REC CAMPUS EXPANSION
PICKLEBALL COURT
 2686 S GOLIAD ST (SH 205)
 ROCKWALL, TX 75032

SP2024-046: Site Plan for 2686 S. Goliad Street

PROJECT NUMBER: SP2024-046
PROJECT NAME: Site Plan for 2686 S. Goliad Street
SITE ADDRESS/LOCATIONS: 2686 S GOLIAD ST

CASE CAPTION: Discuss and consider a request by Frank Polma, PE of R-Delta Engineers, Inc. on behalf of Stephen Geiger Rayburn County Electric Cooperative for the approval of a Site Plan for Private Recreation Facilities on a 1.57-acre parcel of land identified as Lot 1, Block A, Estep Subdivision, City of Rockwall, Rockwall County, Texas, zoned Planned Development District 44 (PD-44) for Commercial (C) District land uses, situated within the SH-205 Overlay (SH-205 OV) District, addressed as 2686 S. Goliad Street [SH-205], and take any action necessary.

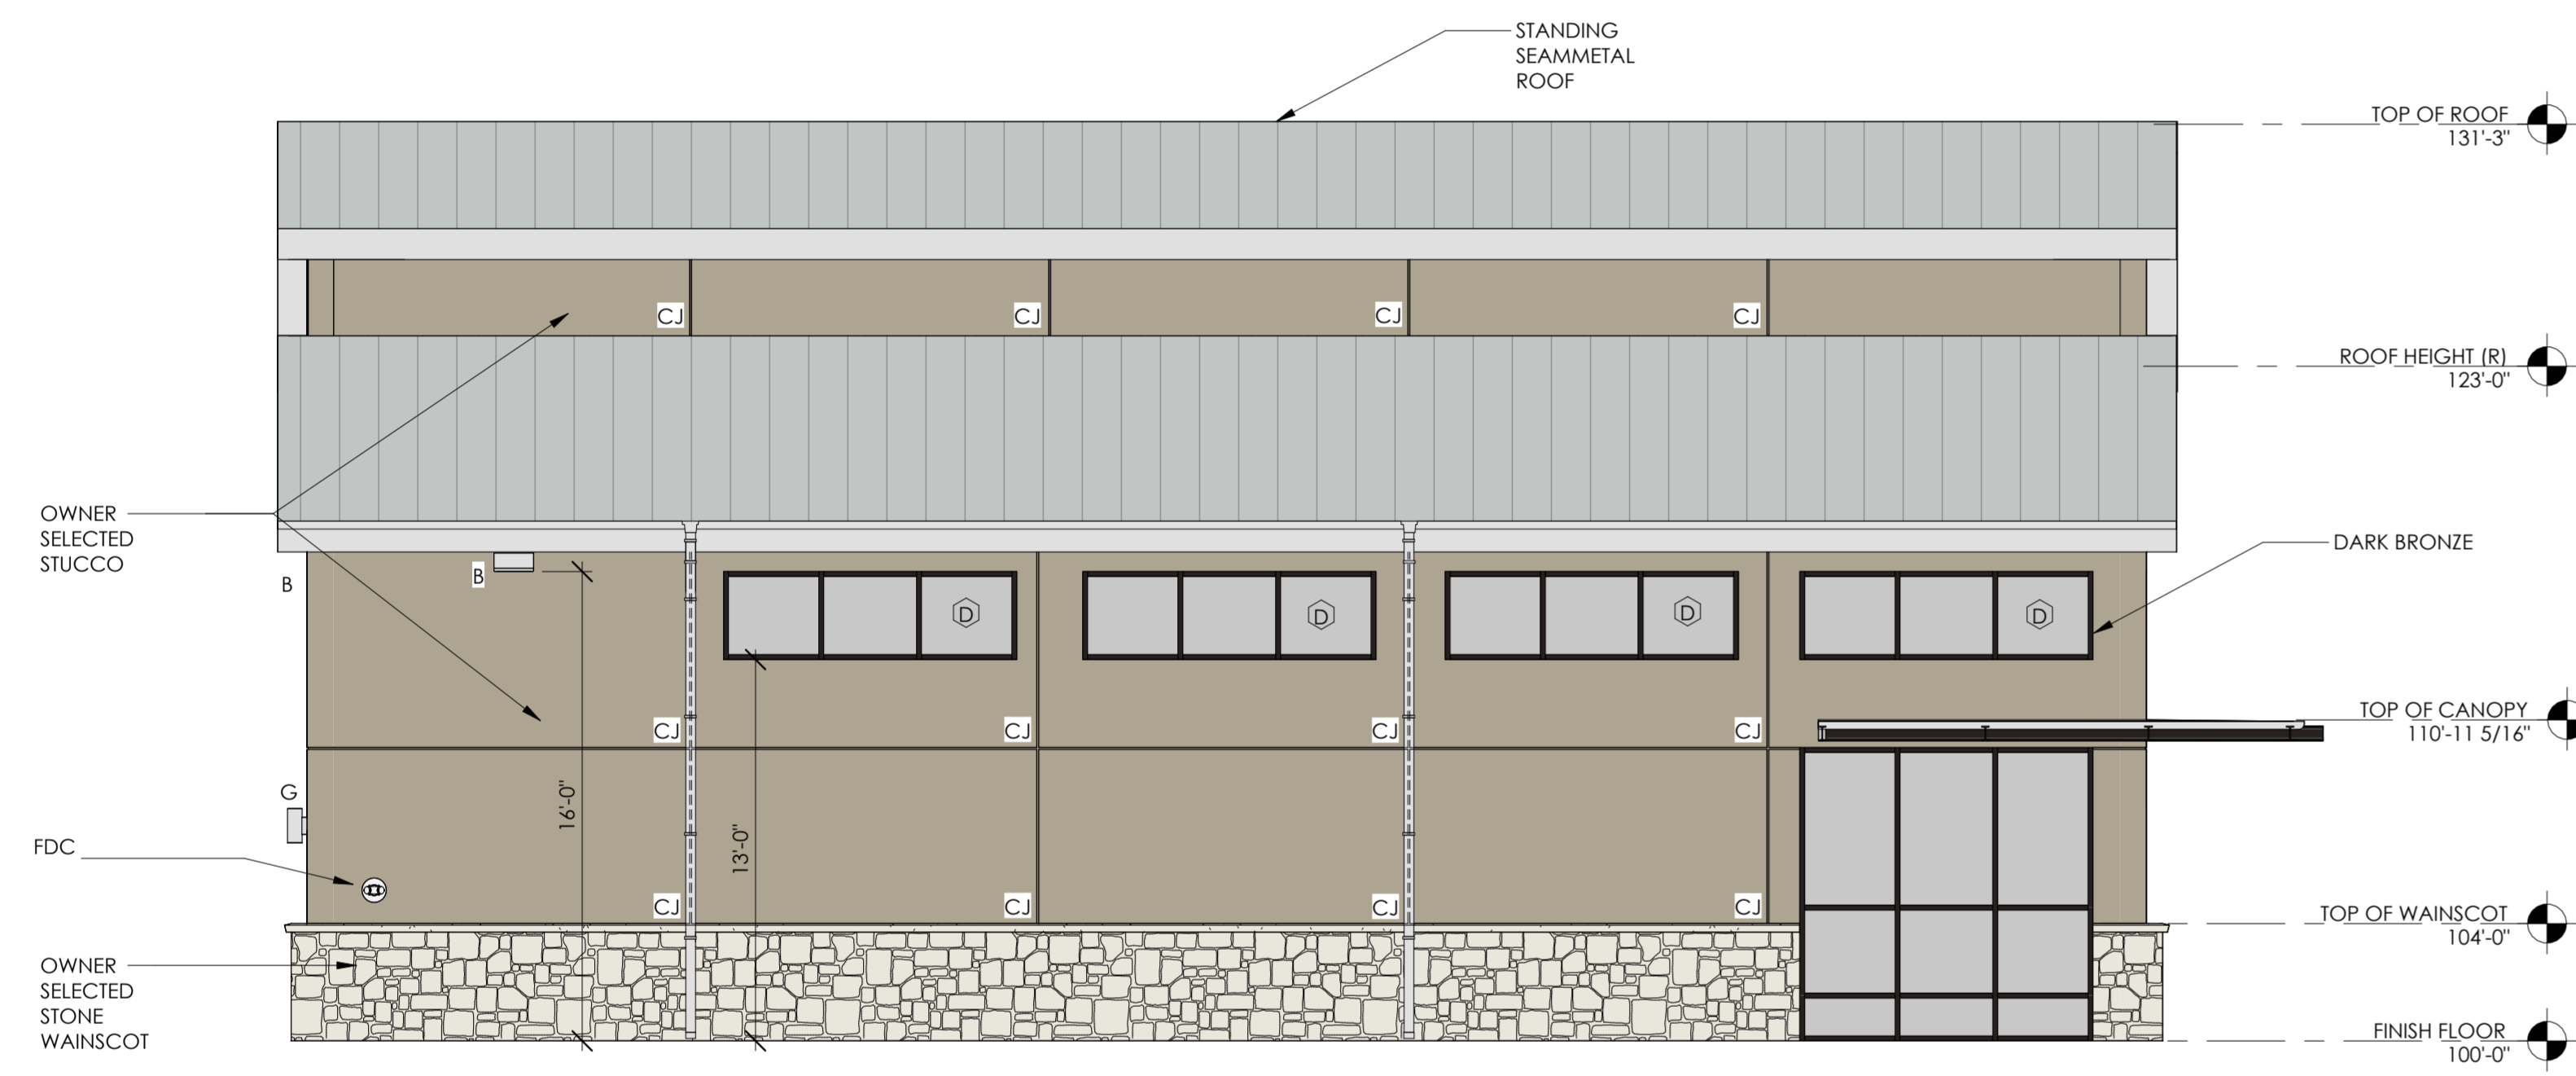
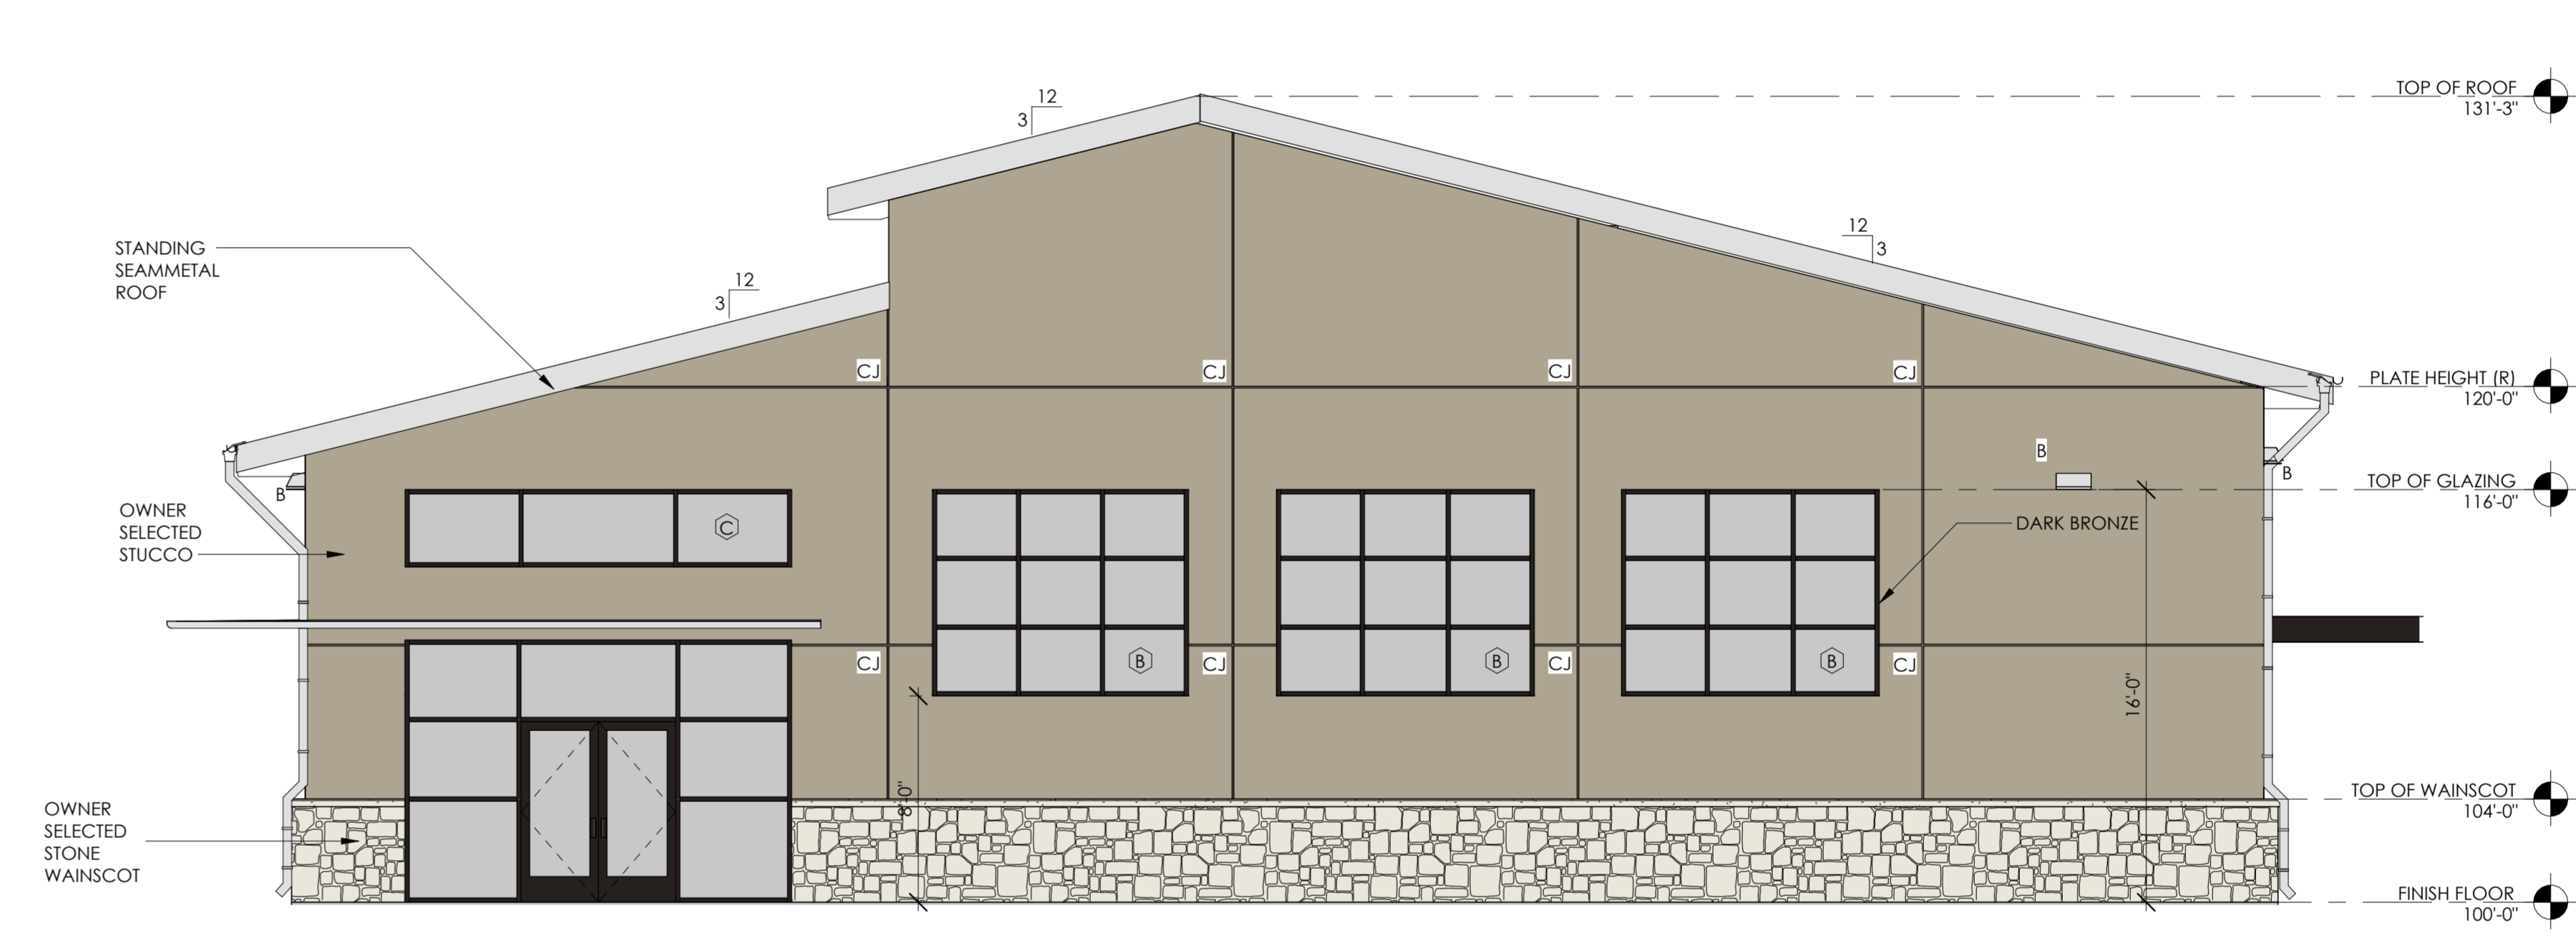
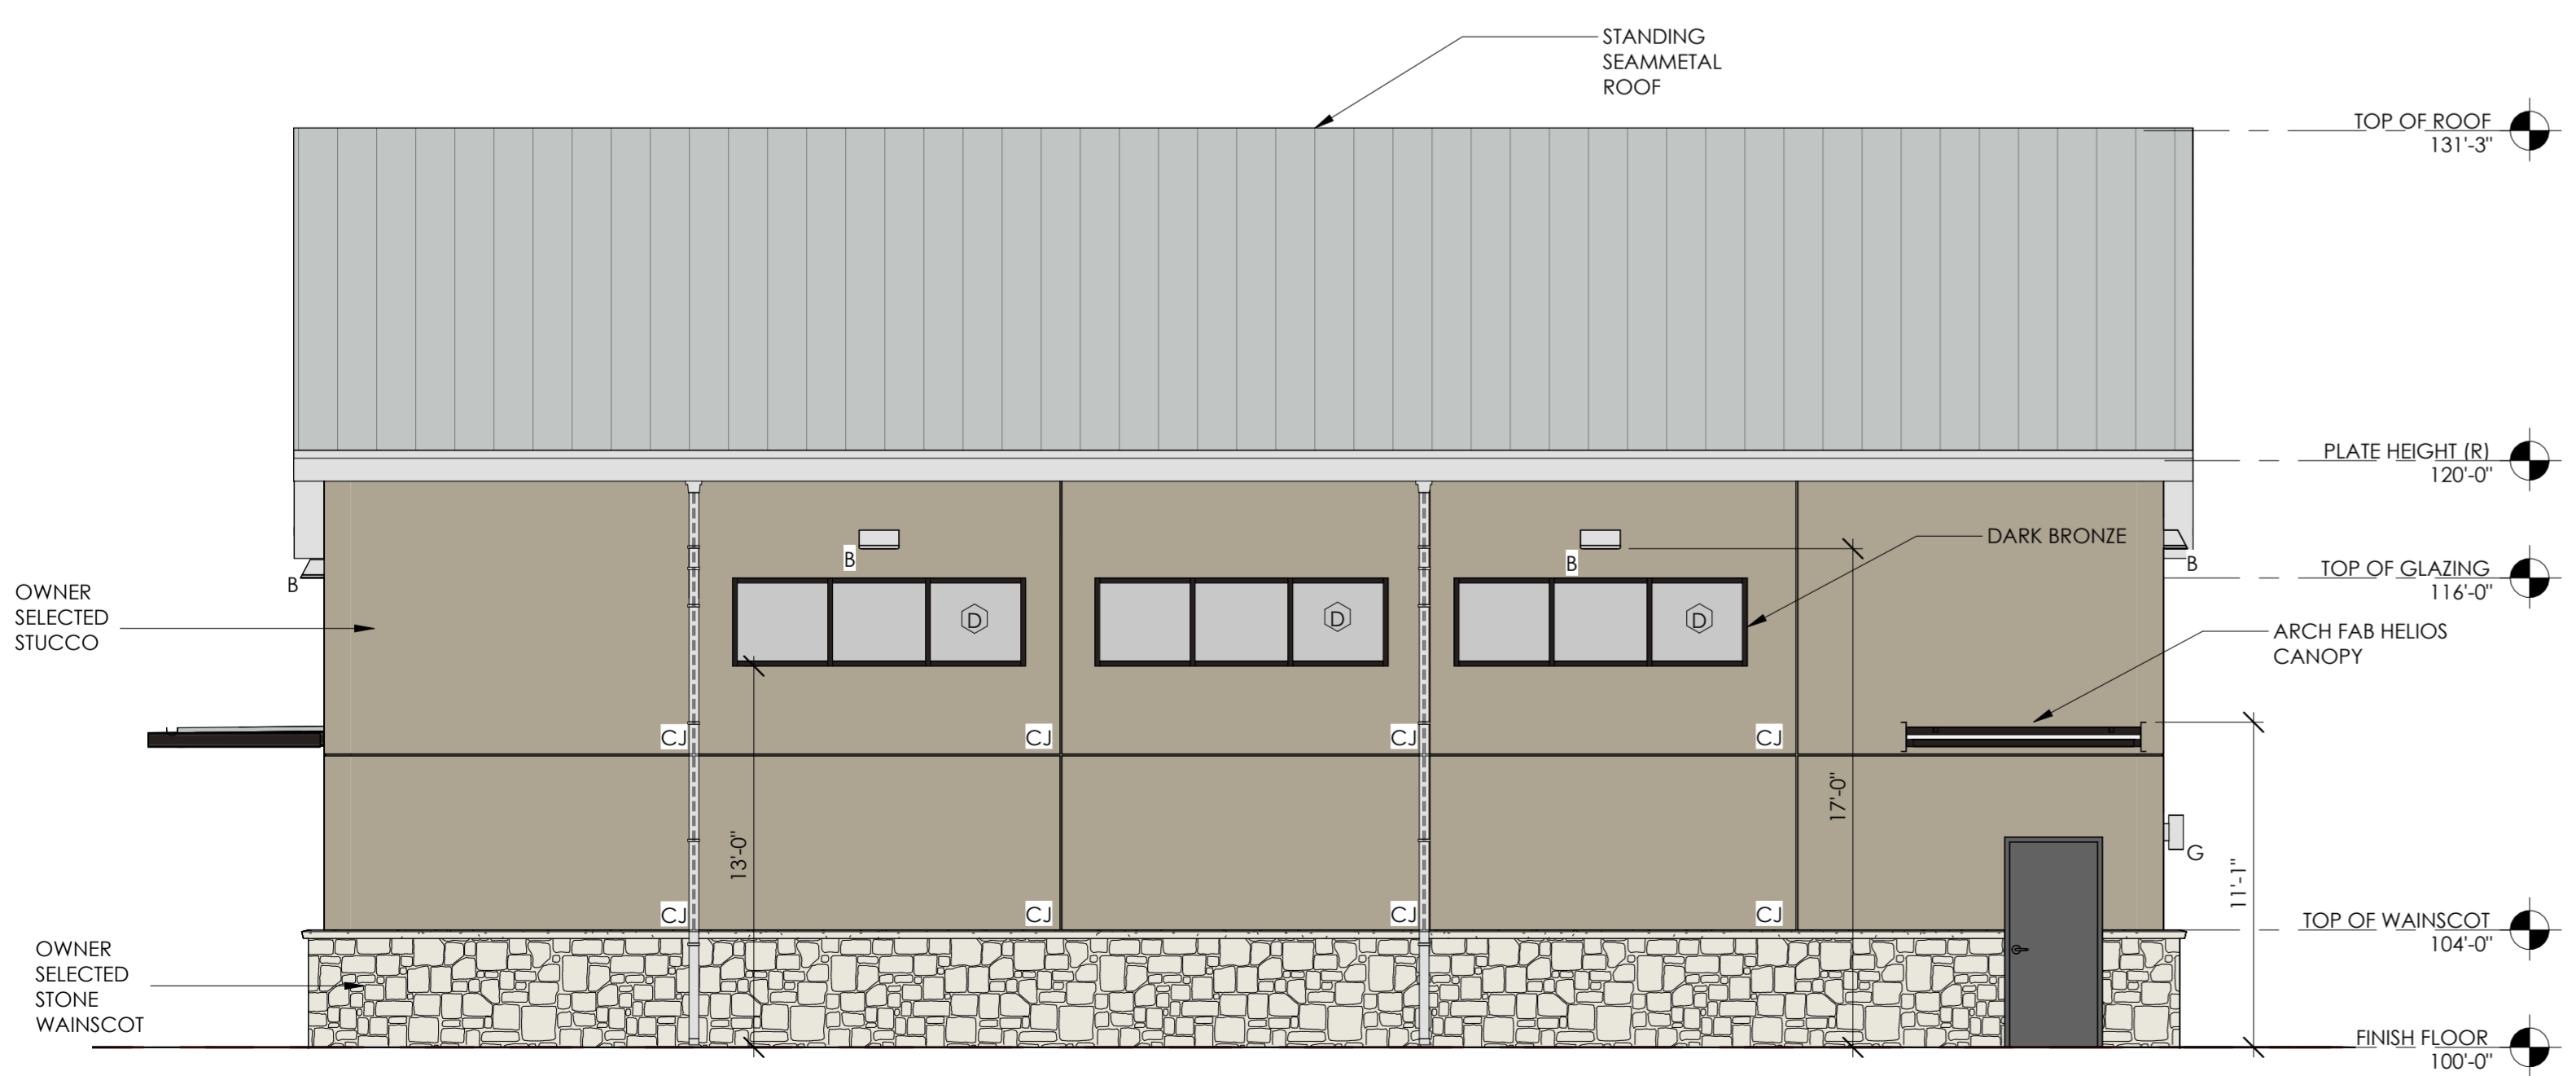
- (5) Please clarify if there will be any RTUs. If so, they must be crosshatched on the building elevations. (Subsection 01.05. C, of Article 05, UDC)
- (6) Provide a note that there will be no outside storage or above ground storage tanks. (Subsection 01.05. D, of Article 05, UDC)

- (1) Please update the table indicating the percentage surface area for each of the proposed materials. This should not include the roof. This will change the material percentages for the stone and stucco. Based on this, the stone may be over the 20% stone requirements (Subsection 04.01, of Article 05, UDC)
